Monticello Nuclear Generating Plant
2807 West County Road 75
Monticello, MN 55362-9637

MONTICELLO NUCLEAR GENERATING PLANT
Docket No. 50-263 License No. DPR-22

Supplement to Revision to Technical Specification Administrative Controls
and Other Miscellaneous Changes

Current Technical Specification Pages Marked Up with Proposed Changes

Change ①

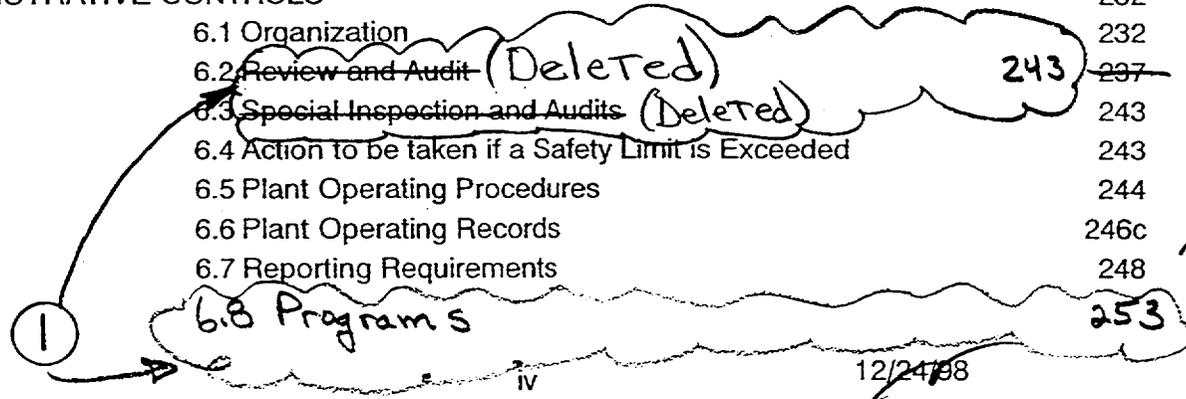
D. If it is discovered that a surveillance was not performed within its ~~specified frequency~~, then the affected equipment shall be declared inoperable.

E. Compliance with 4.0.D may be delayed, from the time of discovery, up to 24 hours or up to the limit of the ~~specified frequency~~, whichever is less. This delay period is permitted to allow performance of the surveillance.

One additional change is included to clarify proposed new Sections 4.0.D and 4.0.E. Proposed Sections 4.0.D and 4.0.E use the phrase "specified frequency" as does Standard Technical Specifications NUREG-1433. However, the Monticello Custom Technical Specifications (CTS) do not define "specified frequency." The equivalent CTS phrase is "time interval" as used in Section 4.0.B. Therefore, it is proposed in this supplement to change the proposed wording of Section 4.0.D from "its specified frequency" to "the extended time interval allowed by 4.0.B." In Section 4.0.E, "specified frequency" will be changed to "time interval." This does not change the intent of our original submittal. Therefore, the original No Significant Hazards Consideration remains valid.
